Transmission Families: Gen 3 Automated

Pre-Authorized Warranty Repair Guideline RWRG0050

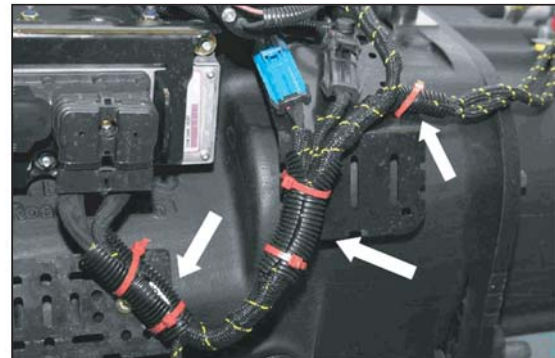
Harness is chaffing on the edge of the harness bracket causing a short.

Inspect the transmission harness by disconnecting the harness from the TECU and cutting the ty-wraps at the mounting bracket.

If the harness has not worn through the braiding, then add convoluted tubing and secure with two ty-wraps.

If the harness has worn through the braiding, install a new transmission harness Part # K-3681 and add convoluted tubing and secure with two ty-wraps.
